GULF STATES UTILITIES COMPANY

May 22, 1985
RBG - 21090
File Code: G9.5

River Bend Station - Unit 1
Docket No. 50-458

Provided for your information are Gulf States Utilities Company (GSU) Final Safety Analysis Report (FSAR) changes that were identified during GSU's indepth review of the River Bend Station Technical Specifications. These changes are provided to ensure consistency between the Technical Specifications and the FSAR.

Figure 4.3-18 RIVER BEND STATION – FSAR
HOT OPERATING, EOC-1 SCRAM REACTIVITY
(\$) AS A FUNCTION OF CONTROL FRACTION

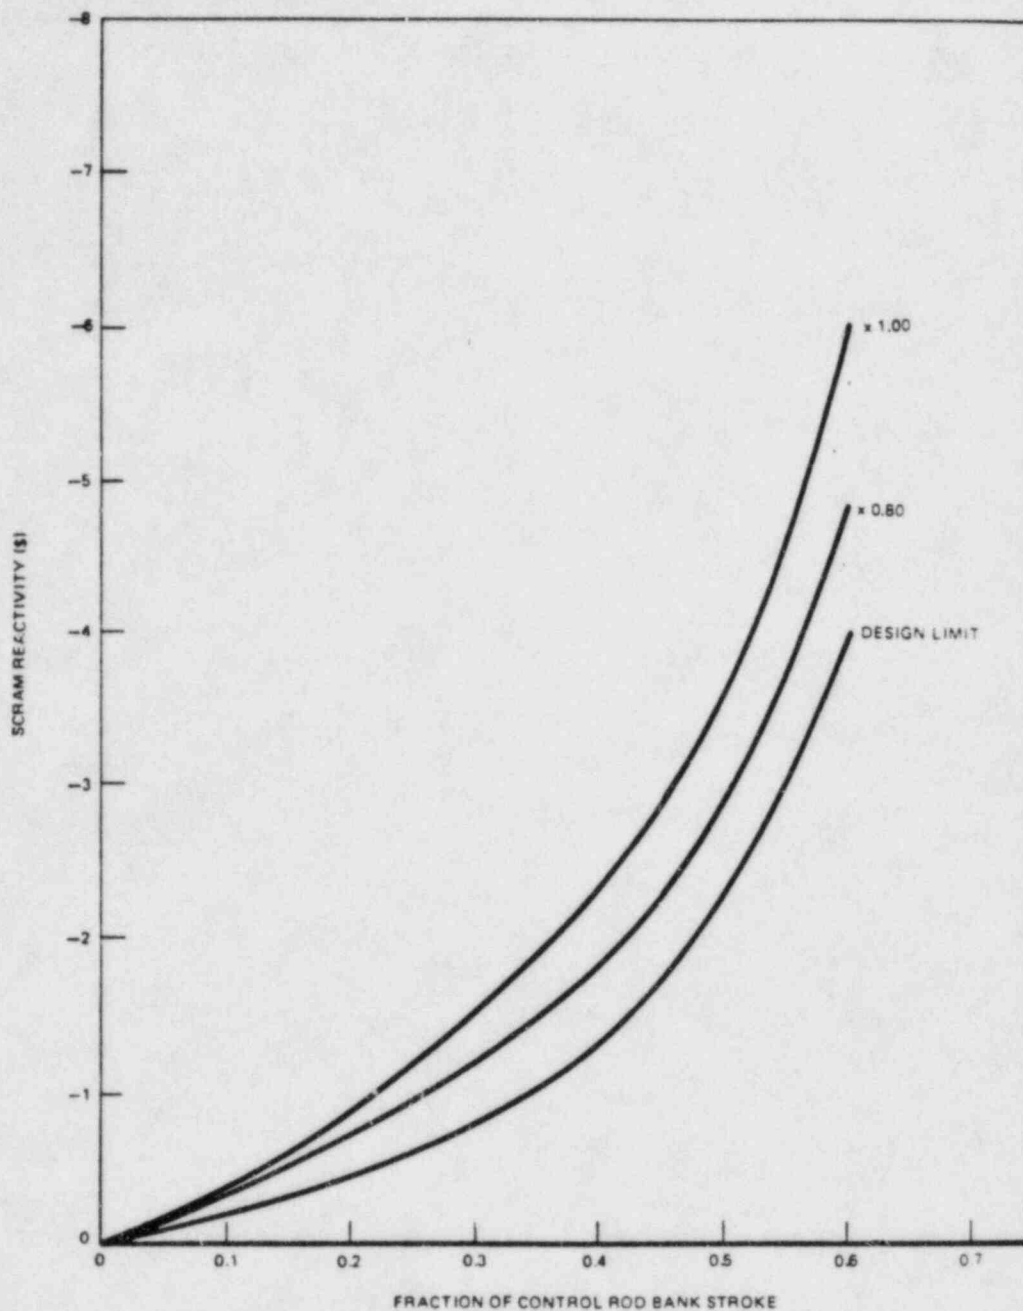
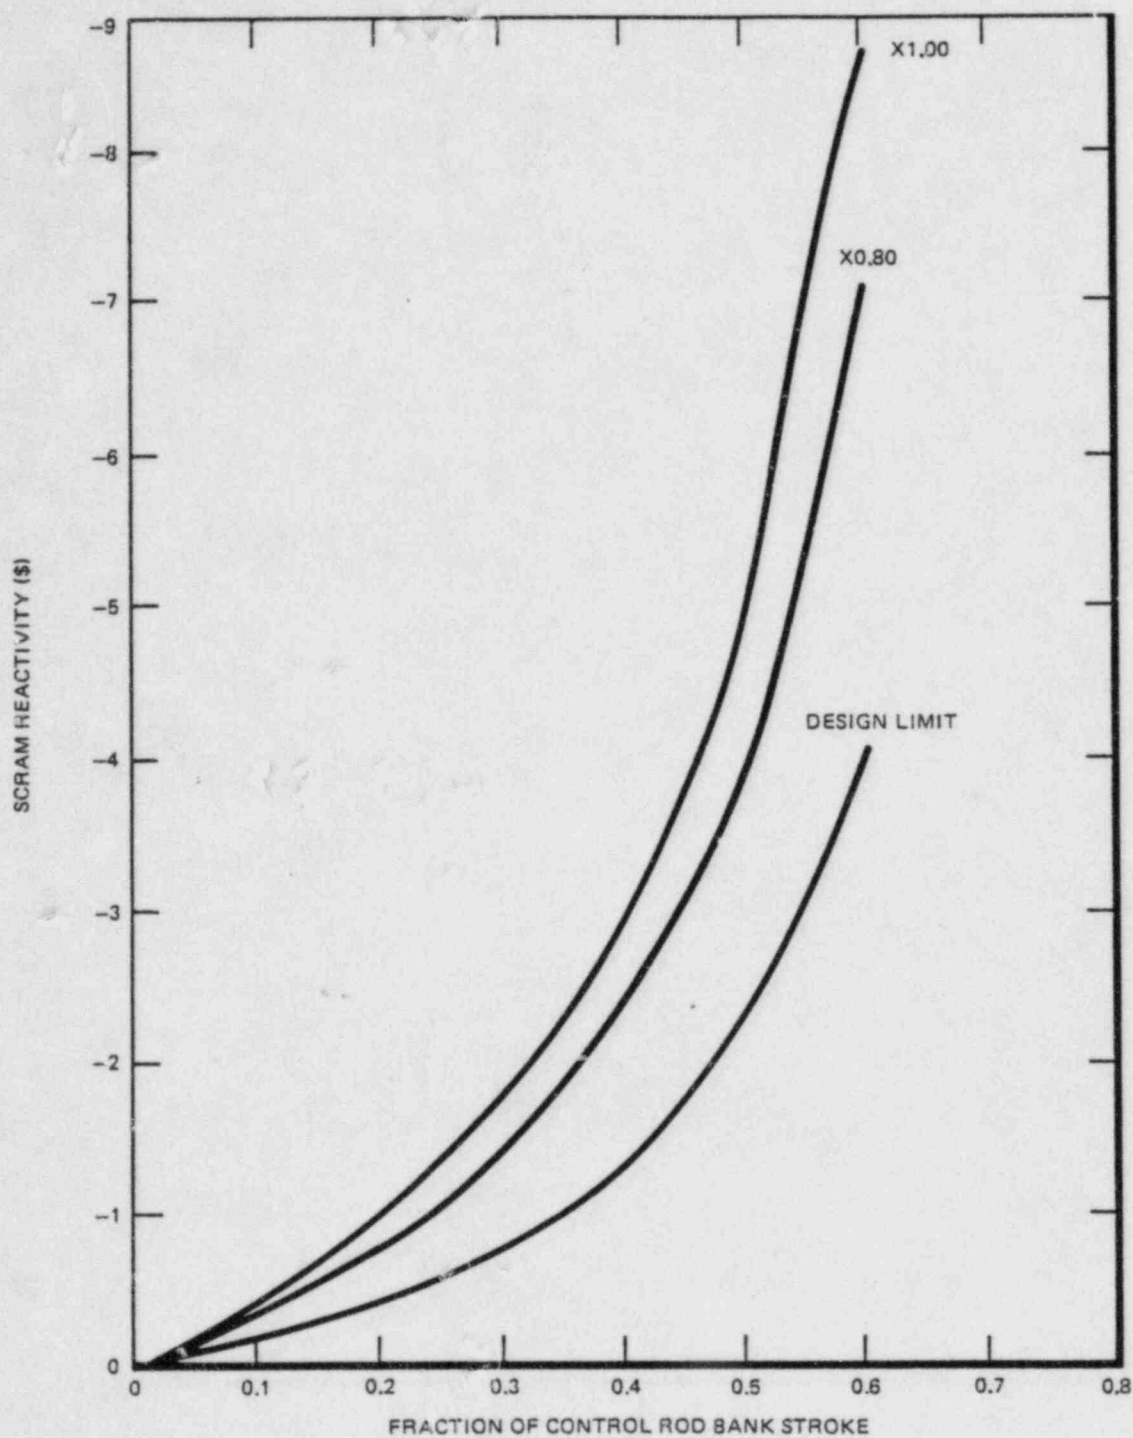
Replace with
attached

FIGURE 4.3-19

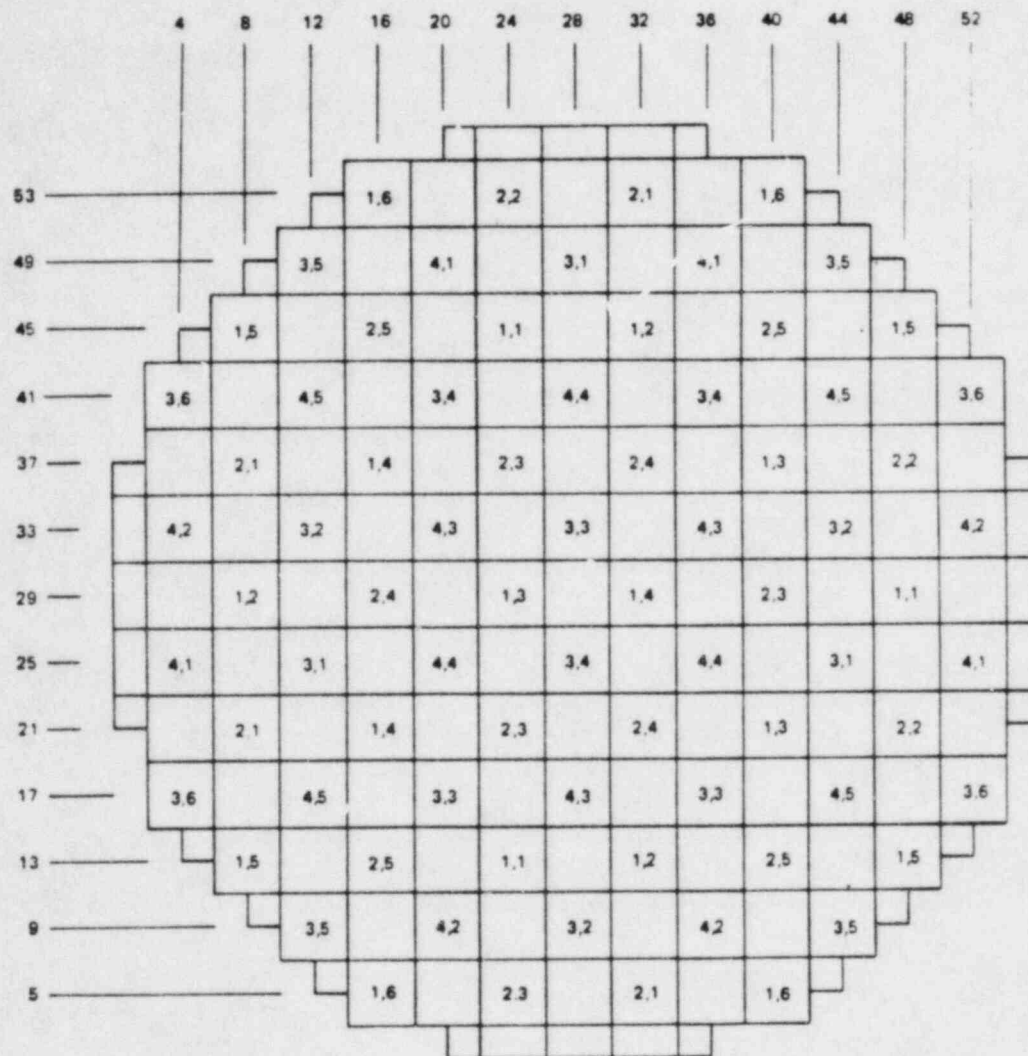
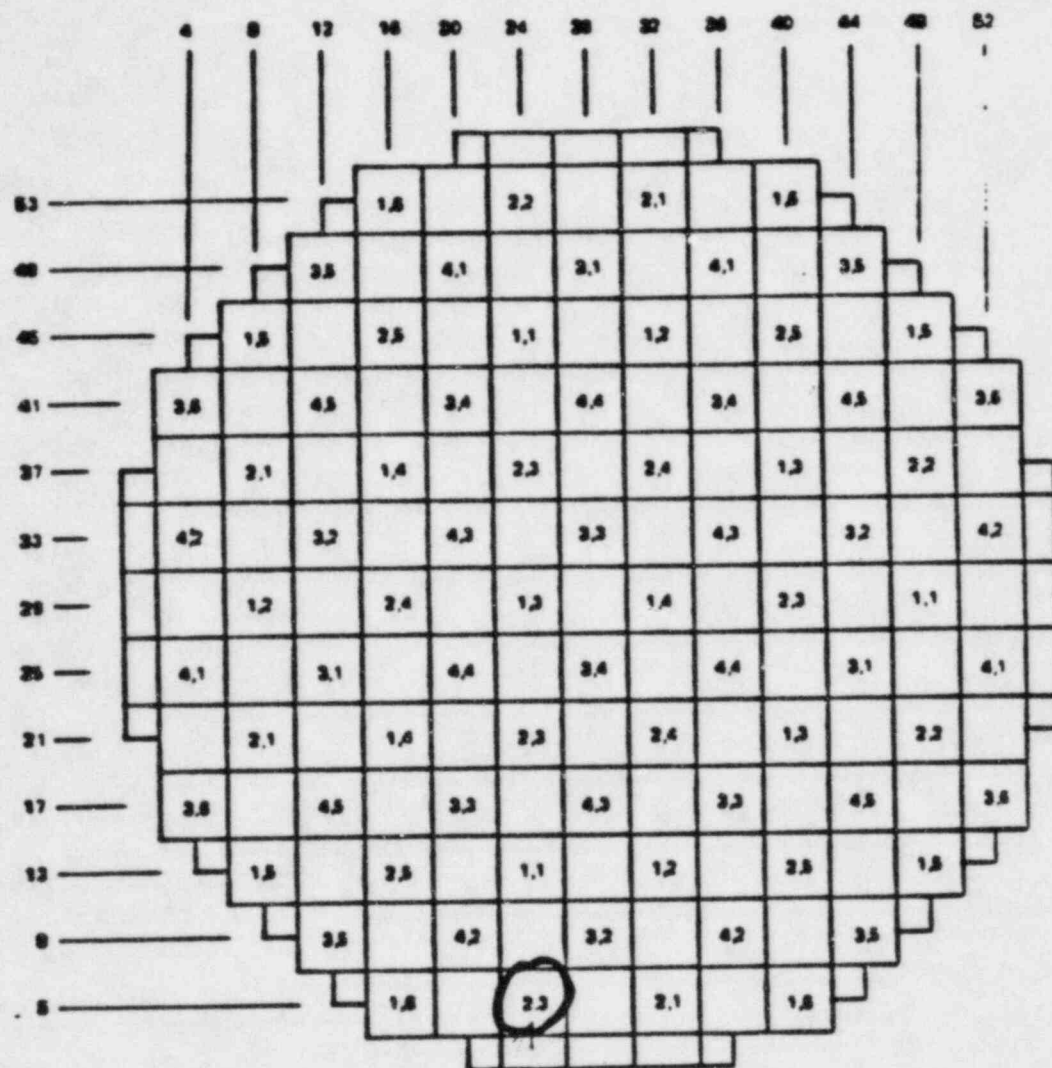
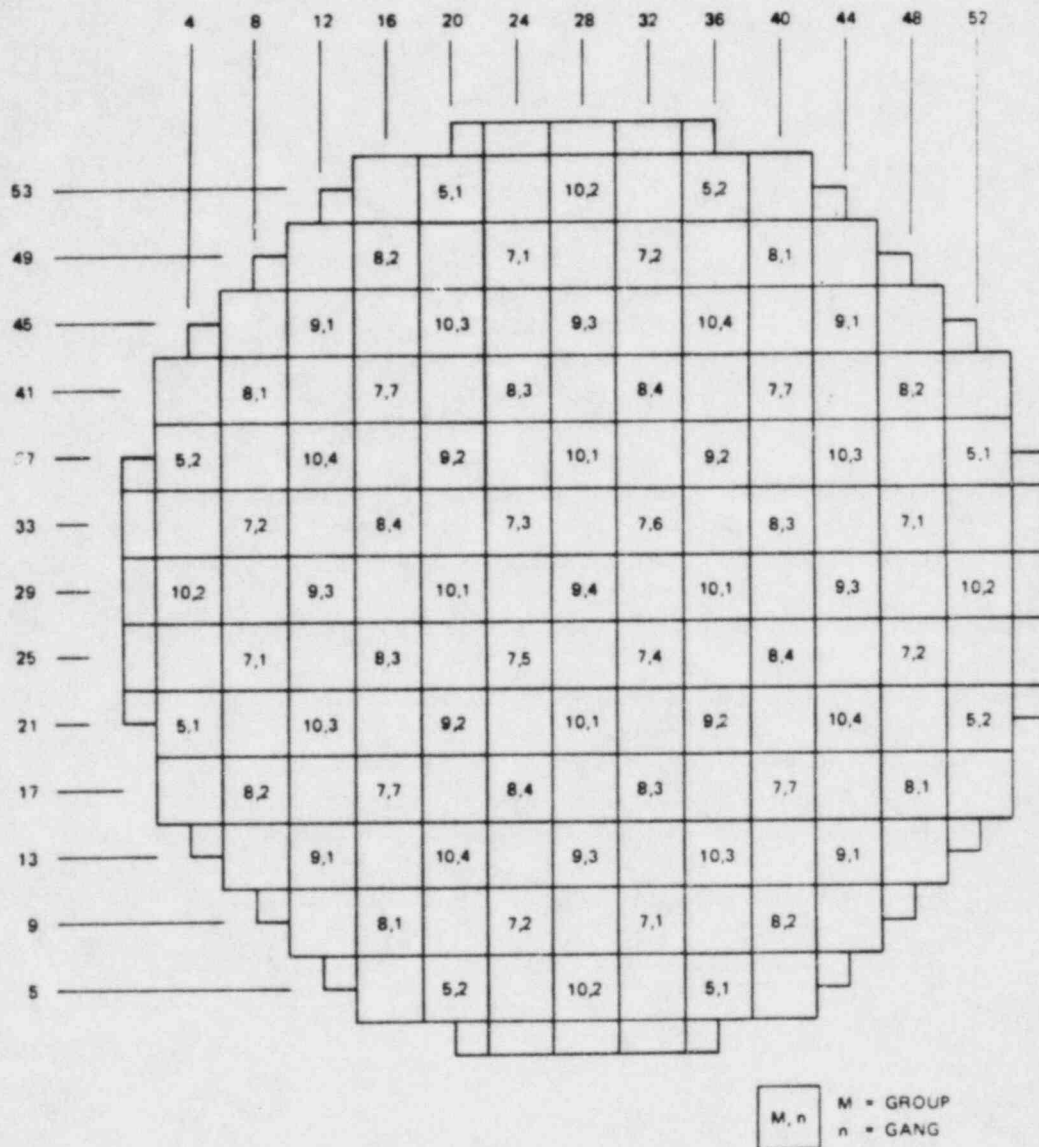
Replace with
attached

FIGURE 4.3-20

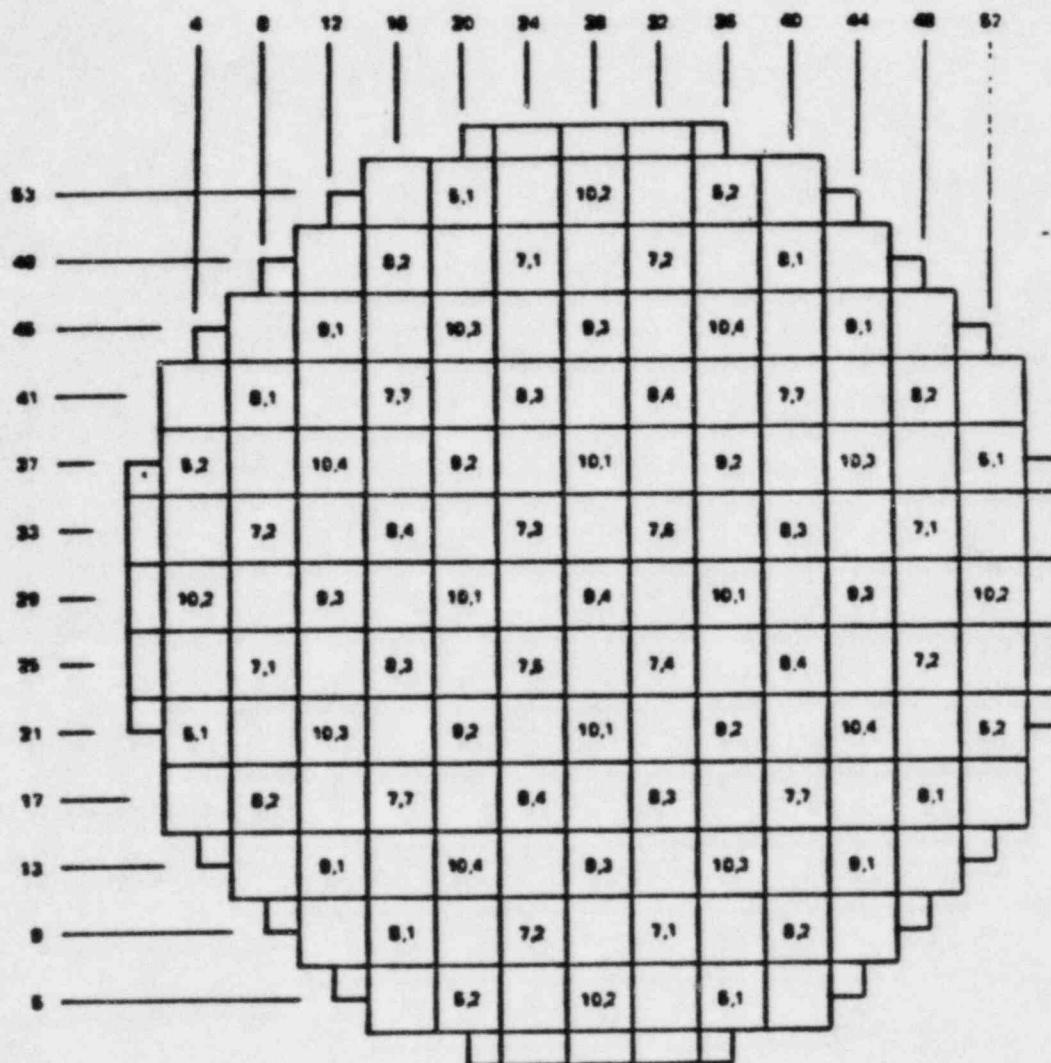
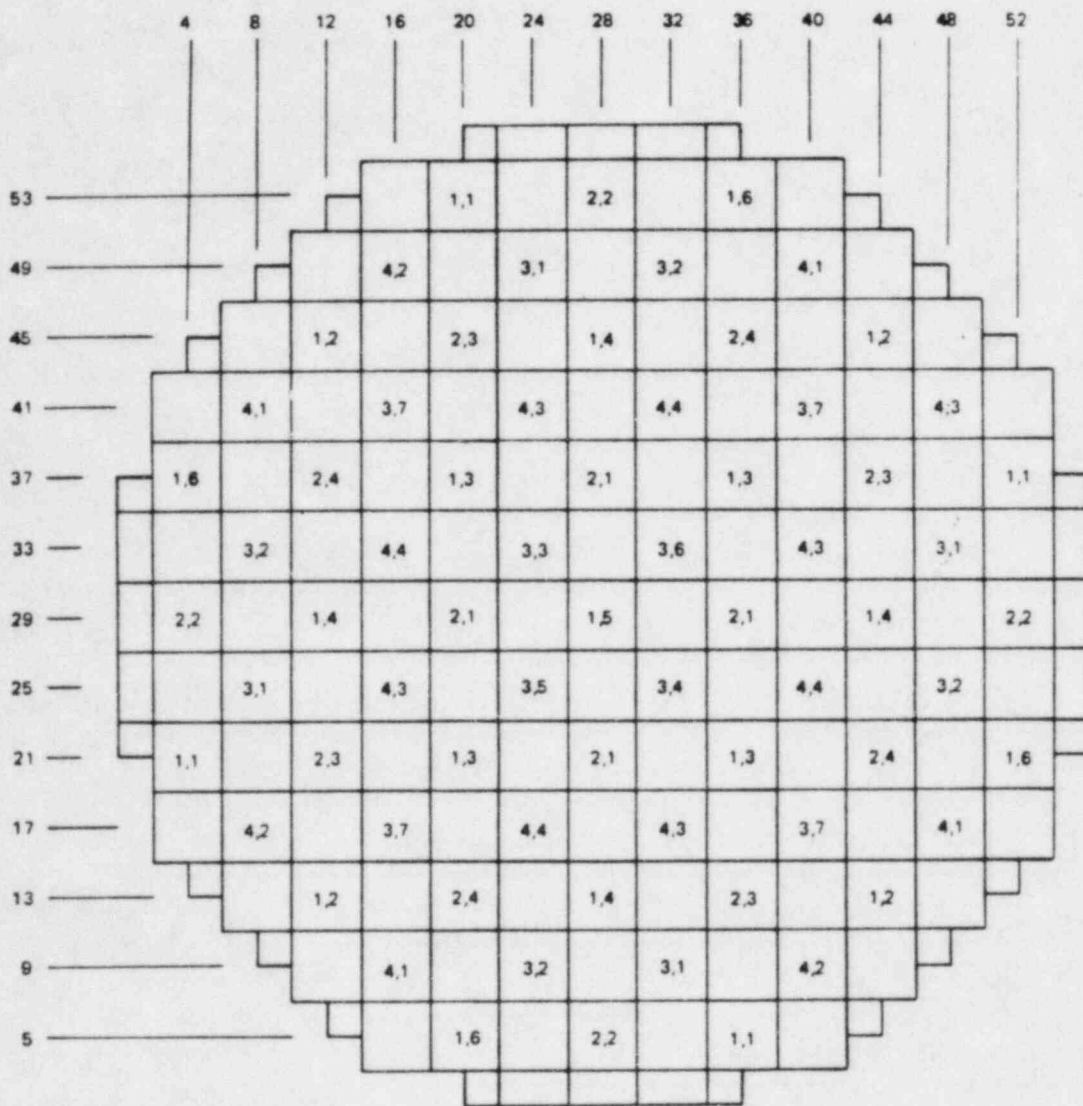
Replace with
attached

FIGURE 4.3-29 21

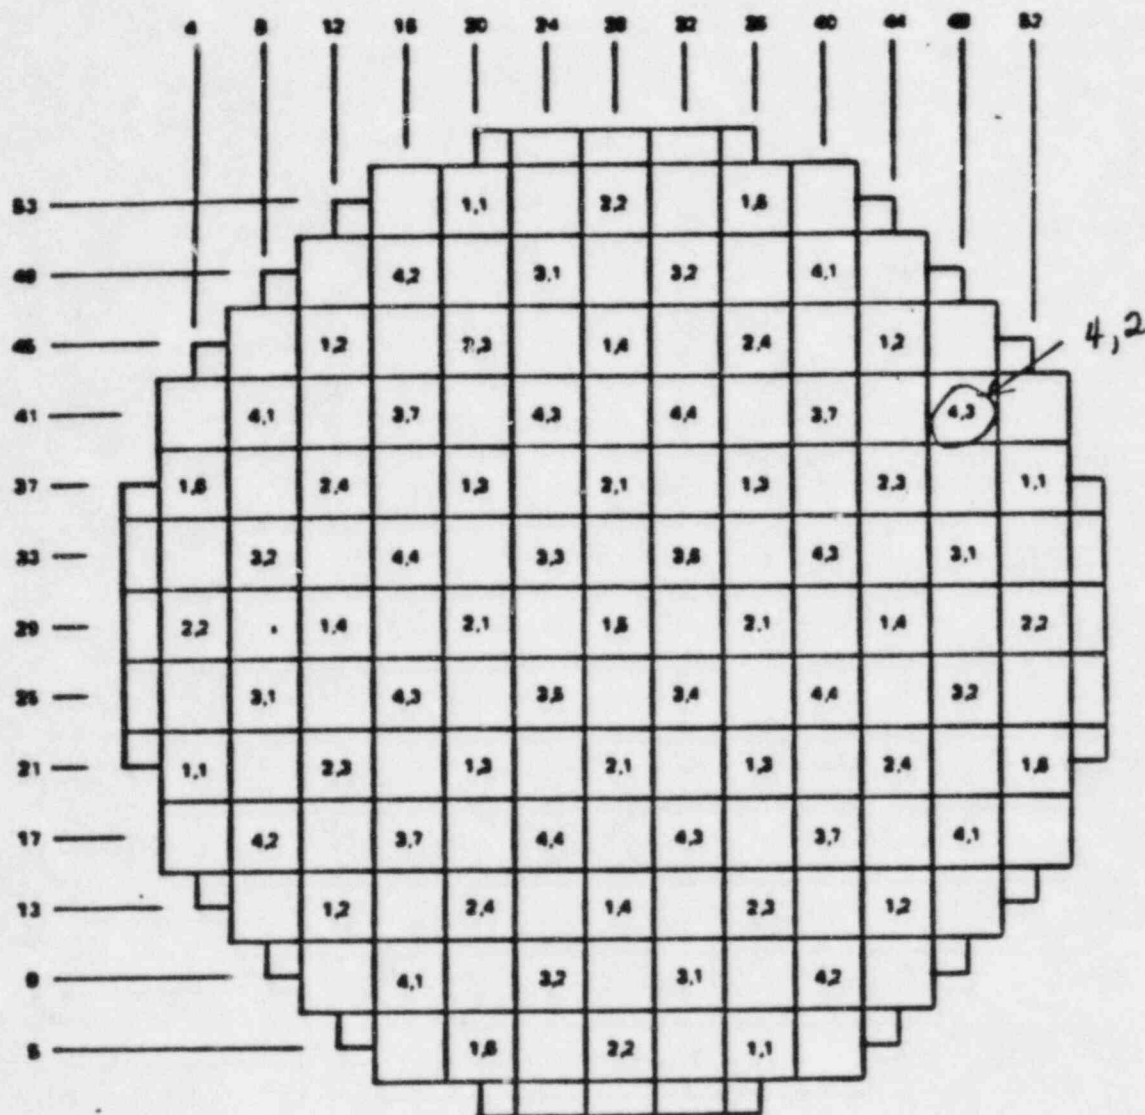
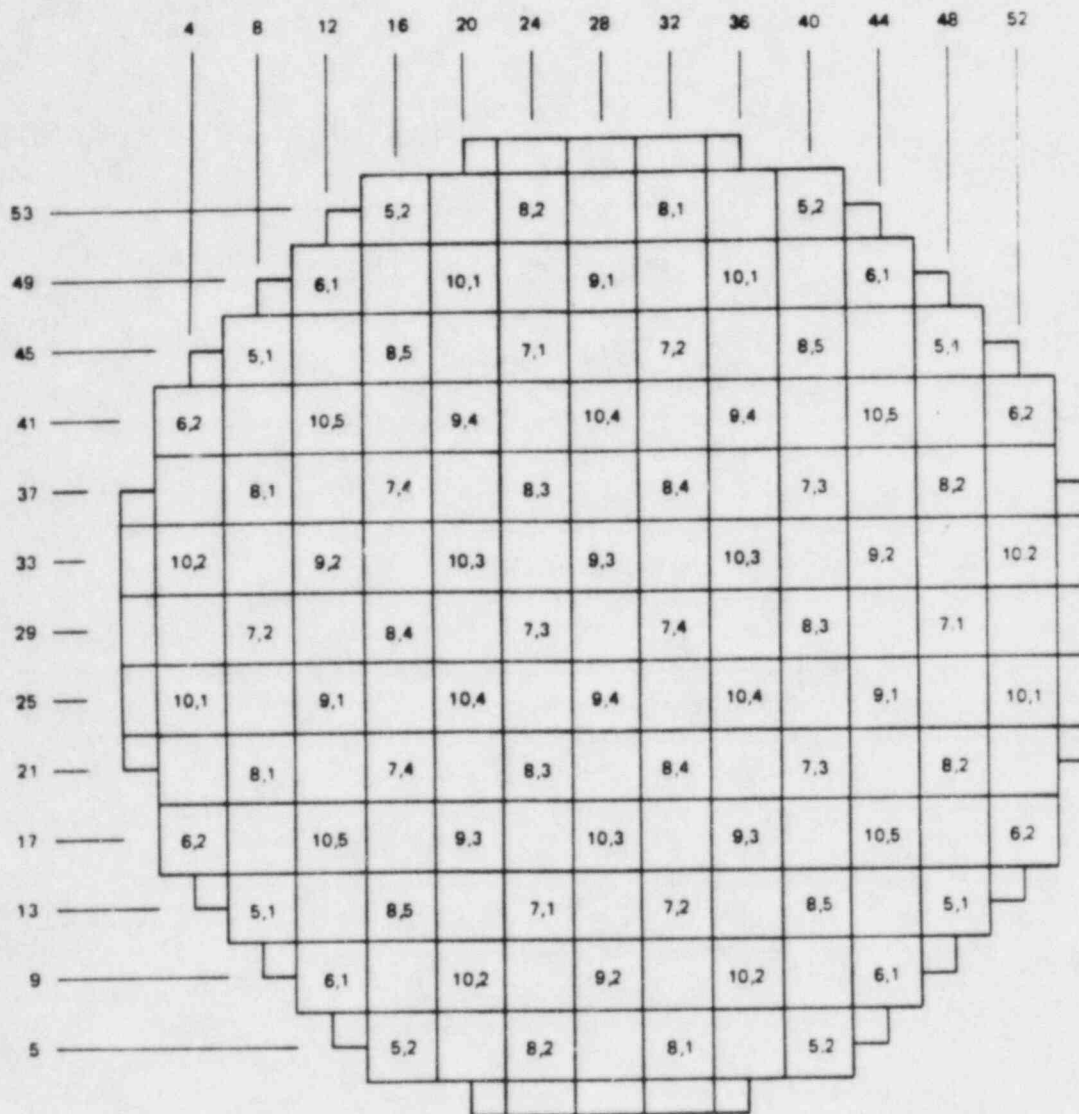
Replace with
attached
